## Addressing Comments #189, #198, #95, #200, #201)

### Comment #189 (Page 267, L10)

Figure 145A-2—Direct measurements of effective  $R_{pse\_max}$  and  $R_{pse\_min}$

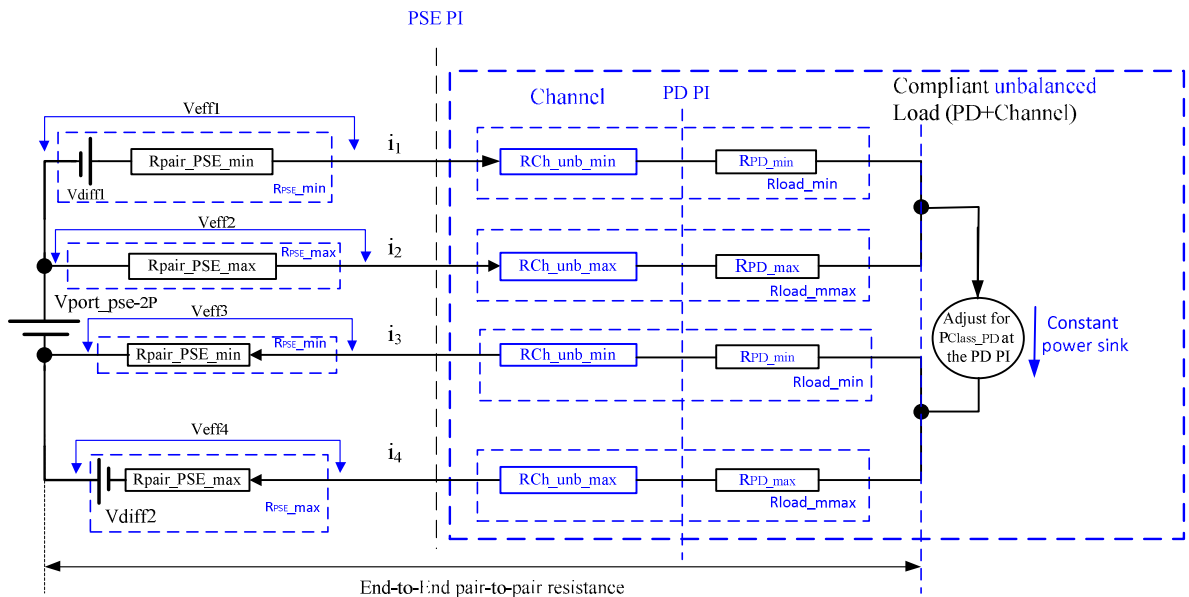
In figure 145A-2 few issues need to be addressed:

- 1) The device on the right in a circle is not sufficiently defined and by the implication of having a different shape is not just a resistance load.
- 2) There is no PI defined in this diagram.
- 3) To provide a diagram of a test network to be used as a load at the PSE PI and a table of values for the test sequence that needs to be stepped through to perform the test.

2. **Replace Figure 145A-2 with the following:**

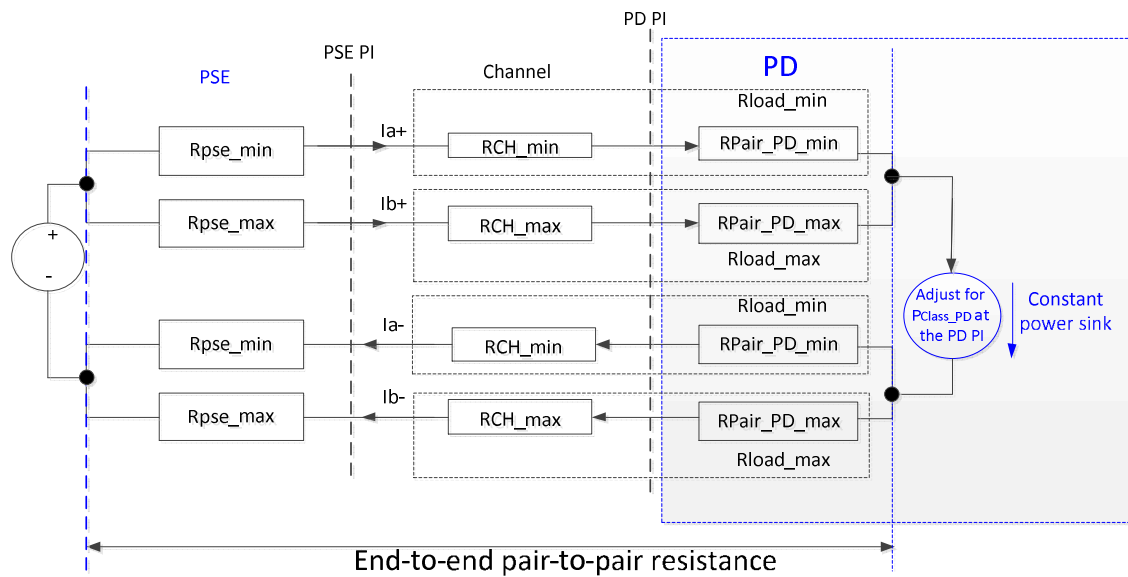
Current text in P802.3bt/D2.4: The box on the far right in the figure is undefined. Is it a PD? Is it a PD minus some of its resistance? Is it a PD minus all its resistance? Is it something else? A test device perhaps. Where is it defined?

Current text in P802.3bt/D2.4: “End-to-end pair-to-pair resistance” The “ends” as used in this evaluation is not defined, not defined as being accessible and under normal circumstances don't even come from the same vendor. Therefore, I don't have a clue how to do this “evaluation”

- 1) The box on the far right in the figure is undefined is a constant power sink which is part of the PD including the Rpd\_min and Rpd\_max.
- 2) All the components in Figure 145-22 are defined in the text in 145.2.8.1 excluding constant power sink which is part of the PD. See proposed update to Figure 145-22.

The end to end pair to pair resistance unbalance is a system parameter that is defined from PSE internal PI circuits up to the PD PI internal circuit. Since PSE PI and PD PI are internal circuits, we are not specifying direct requirement to the end to end pair-to-pair resistance unbalance. We did huge mathematical work to break the parameter to its components i.e. PSE PI, Channel and PD PI. In order to complete the understanding of the reader what is this term, it is describes in Figure 145-22 and we need to add text to explain from which ends it is defined.

1. Update Figure 145-22 as follows:

2. Add the following notes below Figure 145-22.

1. The PD in Figure 145-22 include constant power sink that obeys to Equation 145-2.
2. The end to end pair to pair resistance unbalance is evaluated from the PSE or PD at the point when the total current over two pairs of the same polarity (Icon) is split to its two components per Equation 145-8.
